UNITED STATES PATENT AND TRADEMARK OFFICE

APPLICATION NO.	FILING DATE	FIRST NAMED INVENTOR	ATTORNEY DOCKET NO.	CONFIRMATION NO.
10/538,554	01/09/2006	Fabian Kollmann	D4700-00399	5082
8933	7590	12/11/2007		
DUANE MORRIS, LLP IP DEPARTMENT 30 SOUTH 17TH STREET PHILADELPHIA, PA 19103-4196			EXAMINER MAHONE, KRISTIE ANNETTE	
			ART UNIT 3751	PAPER NUMBER
			MAIL DATE 12/11/2007	DELIVERY MODE PAPER

Office Action Summary

DETAILED ACTION

Figure A. Gransow, et al Figure 4.

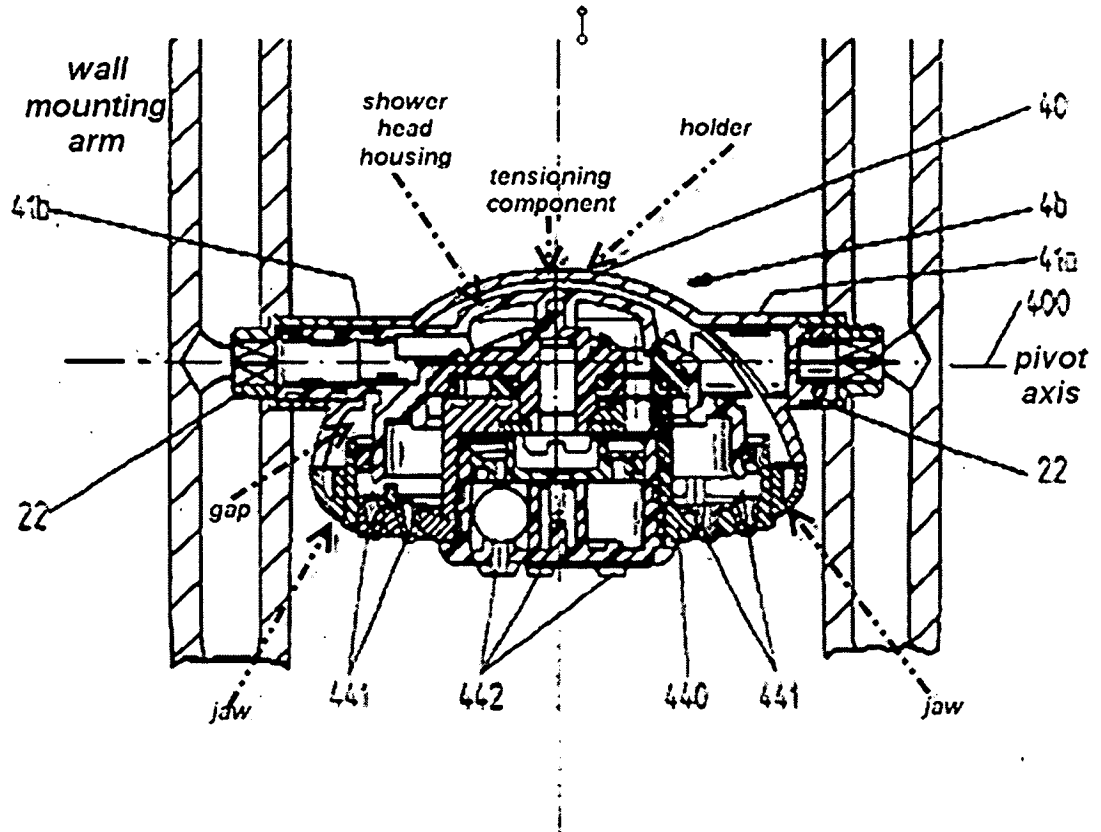
With respect to claims 11-14, 19, and 20, reference is made to Figure A. As schematically shown, that the pivot axis of the holder (400) intersects a housing of the showerhead, near a centroid thereof (Fig. 4). The holder for the shower head is configured to engage a location on a housing of the showerhead (as at an outer perimeter thereof) provided for holding it that is not recognizable as such (based on its shape at that location) and acts by means of a "interference fit" in a withdrawal, or insertion direction. The holder engages the housing of the shower head a two locations on its surface which are approximately opposite and diametrically opposed.

Regarding claims 18, 21-24, and 31, the shower head, shower head housing, holder, tensioning component, and jaws are labeled in Figure A. The jaws on the holder of the shower head are tensioned toward one another while the shower head is inserted. Further note that contact between the tension component and shower head housing takes place over an extended area.
